**ADDENDUM NO. 2 to the**

Project Manual/Bidding Legal Documents  
Avon Lake City School District  
Parking Lot Renovations at Avon Lake High School

This Addendum No. 2 supplements and amends the following documents for the Parking Lot Renovations at Avon Lake High School:

Map B: North Lot – 4” Base Bid, Overlay Alternate

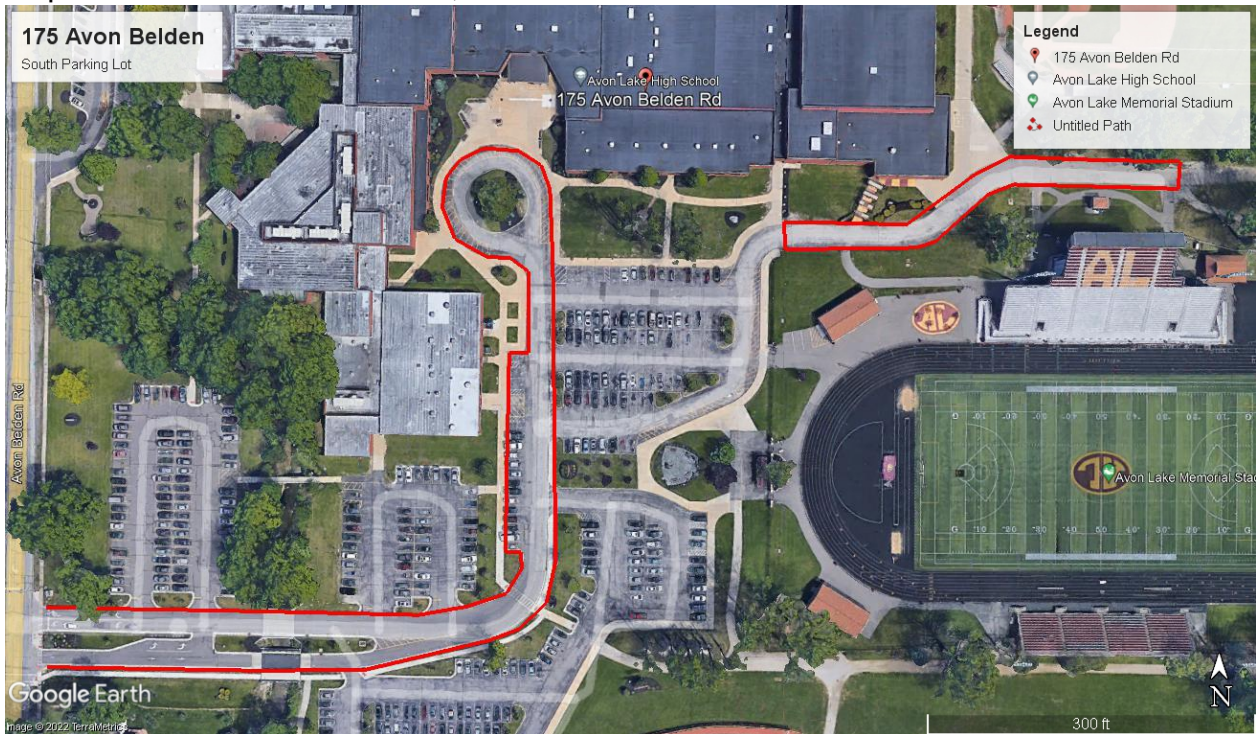
Question: A question was asked about the plan for re-striping.

Answer: Striping will go back as-is, with same colors as existing. Every stall in the North lot has a number in it. North lot has band lines that will need to go back per provided plan. South is the roadway, has a few stalls for striping and possibly some directional arrows but the North lot will be the most striping-intensive.

Map A: South Lot – 6” Base Bid, 4” Alternate

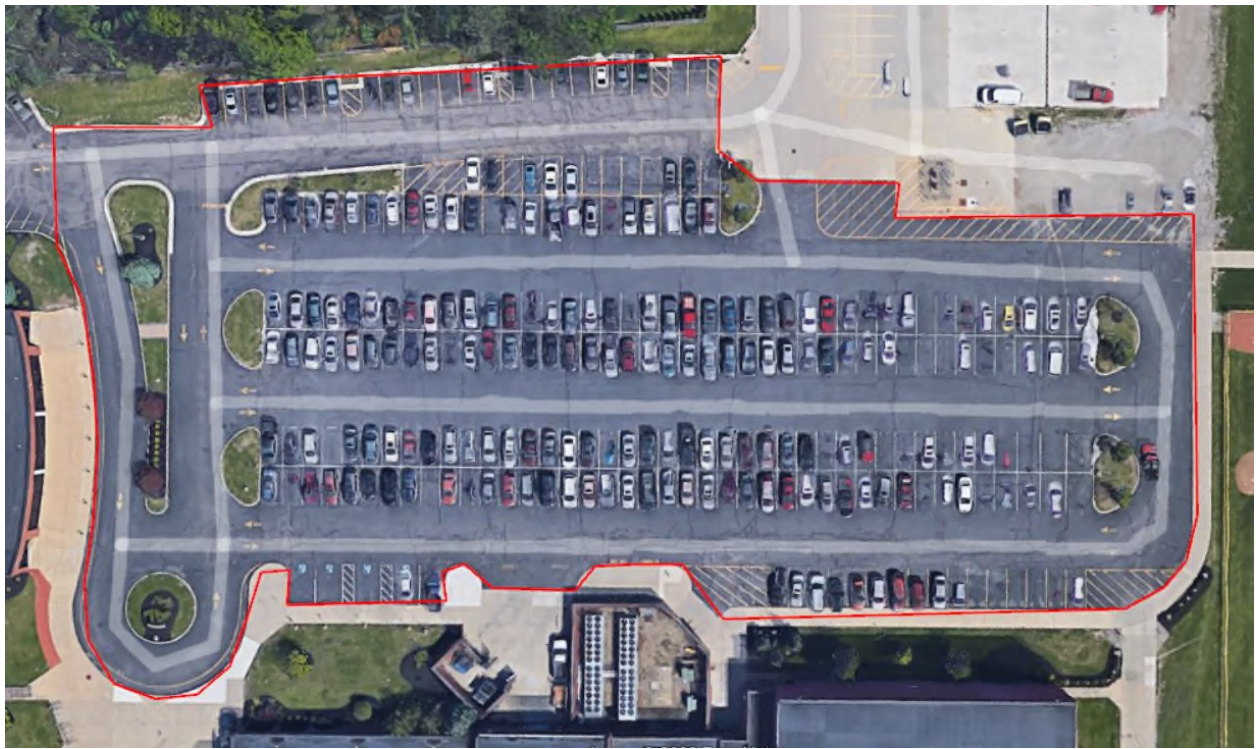
Question: A bidder was confused as to the first aerial (South Lot) not being labeled.

Answer: A typographical error has the label for the first aerial on page 3 of the original spec (page 41 of the bid package), not directly above the South aerial (page 4 of the spec and page 42 of the bid package) as intended. The revised maps attached to this addendum place the label in the correct location for clarity. The South Lot map has also been updated in terms of what is to be covered in the project.

Question: What previous work was done in the lots?

Answer: Some overlays here and there in spots, but not on the full lot or drive. The South Lot map has been updated to reflect a “tradeoff” between a section that was done more recently (where the drive crosses the staff lot) and “Victory Lane” toward Groveland.
